Our Ref: 24-19/001344
Date: 29 January 2025

RE: RESPONSE TO INFORMATION REQUEST IN RELATION TO AN APPLICATION FOR A DEVELOPMENT PERMIT FOR RECONFIGURING A LOT (1 LOT INTO 2 LOTS) OVER LAND LOCATED AT 28 JENSENS CROSSING ROAD, COOKTOWN

We hereby provide the following information in response to Council's Information Request dated 20 January 2025.

Figure 1

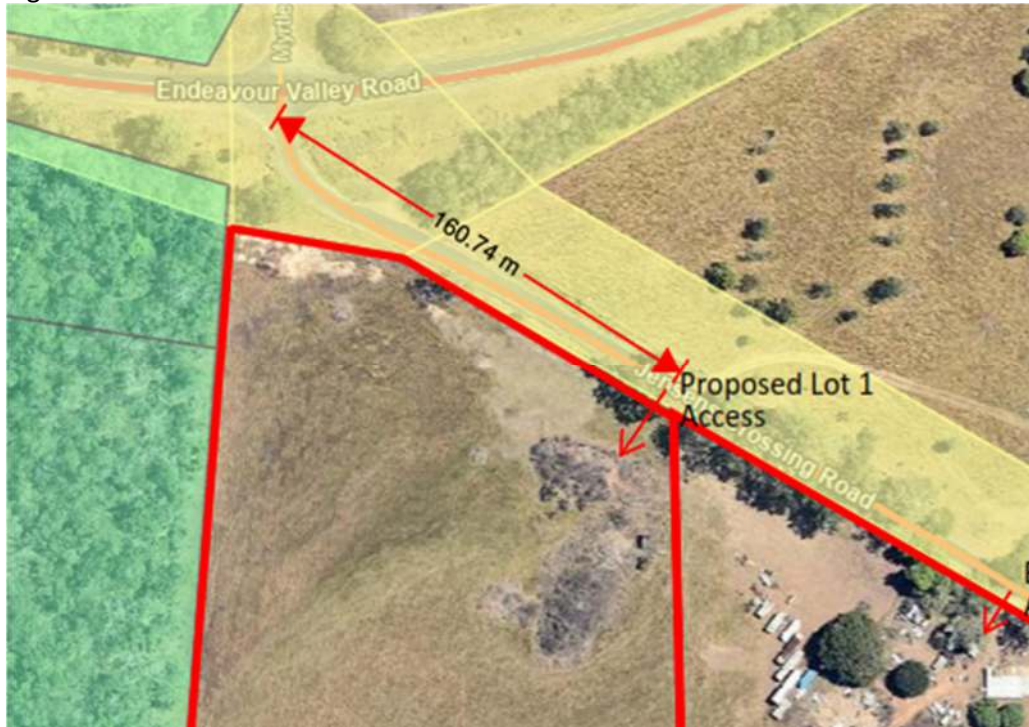
1. The Applicant is requested to amend the Proposed Reconfiguration of a Lot Plan and provide further information demonstrating access to proposed Lot 1. This may include an access easement over the existing internal driveway located within proposed Lot 2 to enable access to proposed Lot 1. Alternatively, the Applicant is requested to amend the Proposed Reconfiguration of a Lot Plan demonstrating provision for an access crossover and driveway from Jensens Crossing Road to the existing dwelling/structures located on proposed Lot 1. This must include an evaluation of sight distance at the proposed access location in accordance with the AS 2890.1:2004 Parking facilities – Off-street car parking.

As noted previously, the proposed access to proposed Lot 1 is located as far as possible from the Endeavour Valley Road intersection, and at approximately 160m separation, is considered to appropriately mitigate any such impacts.

Please see amended Proposed Reconfiguration of a Lot Plan included as **Annexure 1**. The plan illustrates the proposed new access to proposed Lot 1 being at the eastern-most extent of the lot's road frontage, being as far away from the Endeavour Valley Road intersection as possible. Figure 1 below shows this as being approximately 160m.

Proposed Reconfiguration of a Lot (1 Lot into 2 Lots)

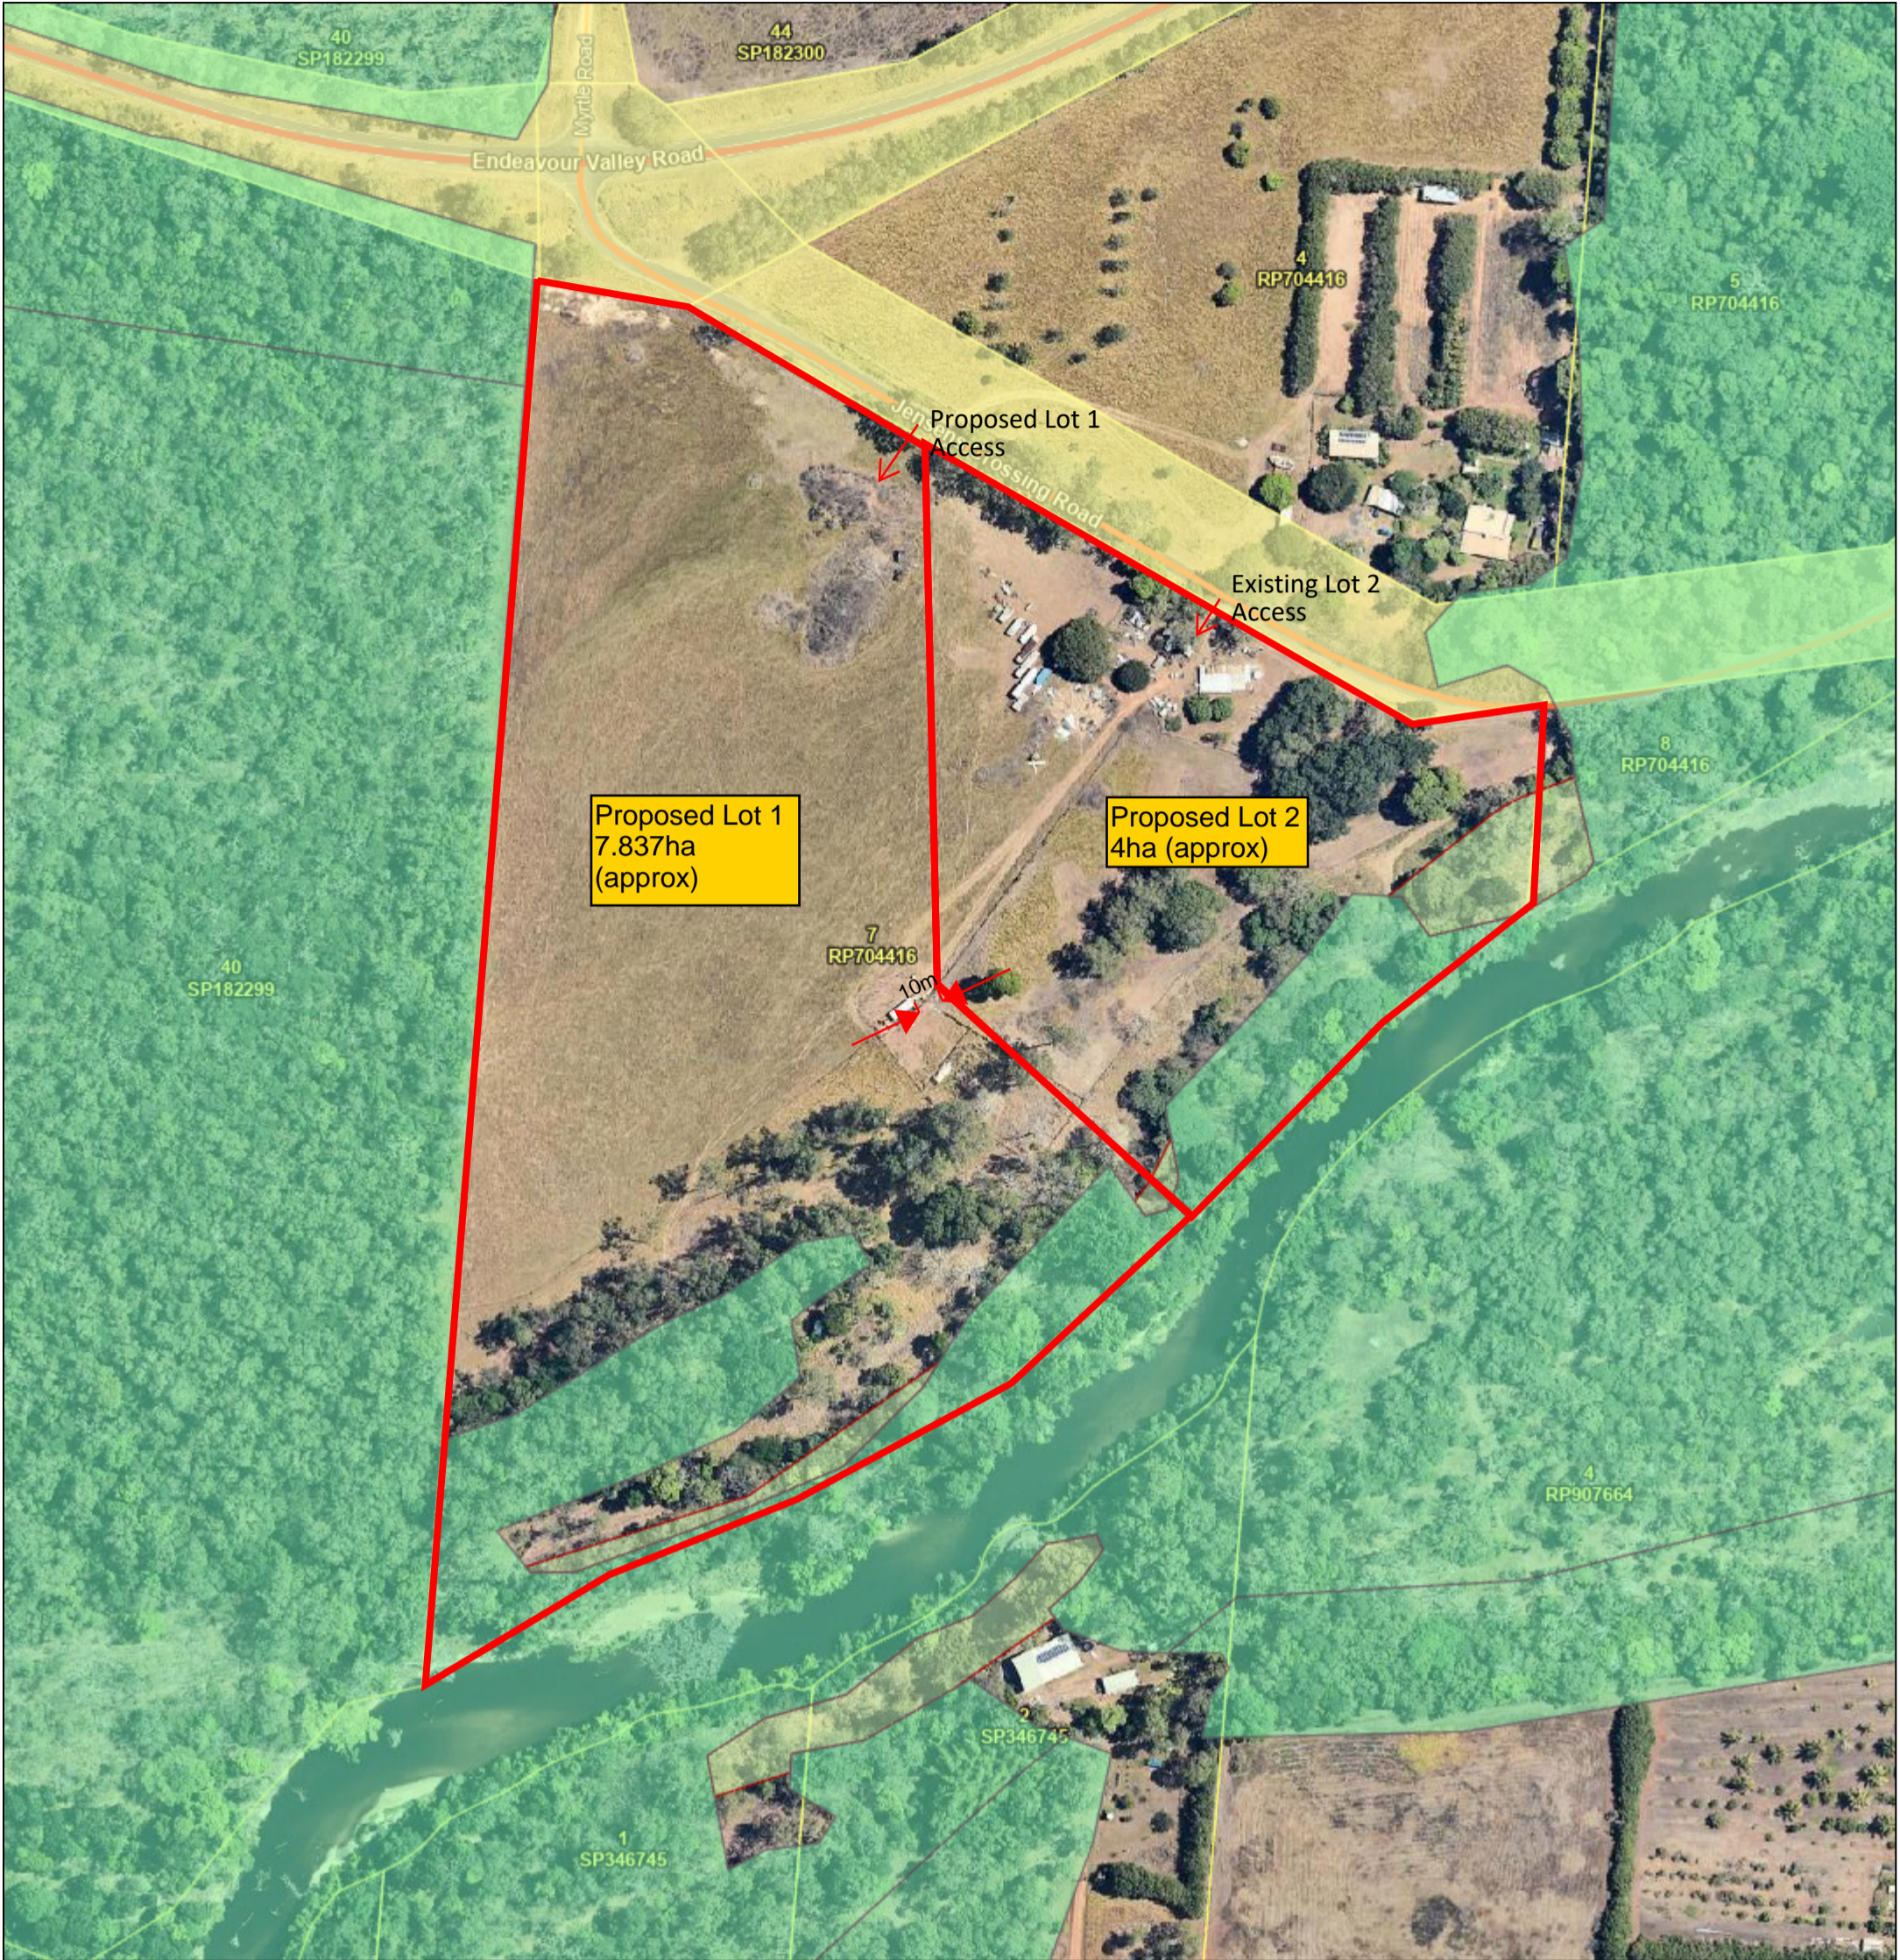
2. The applicant is to demonstrate that each lot, in particular Proposed Lot 1, will have site access;

Please provide an updated site plan to reflect any changes as a result of the details outlined in this Information Request and to ensure it includes the following details:

5. All existing and proposed boundary lines;

6. All existing buildings and structures.

7. All existing and proposed driveway/vehicular crossings; and

8. Dimensions detailing setbacks from all existing structures on proposed Lot 1 to the proposed boundary lines.

As per above, please see amended Proposed Reconfiguration of a Lot Plan included as **Annexure 1** which illustrates the proposed new access to proposed Lot 1.

Please see amended Proposed Reconfiguration of a Lot Plan included as **Annexure 1**.

Please see amended Proposed Reconfiguration of a Lot Plan included as **Annexure 1**.

Please see amended Proposed Reconfiguration of a Lot Plan included as **Annexure 1**.

Please see amended Proposed Reconfiguration of a Lot Plan included as **Annexure 1**.
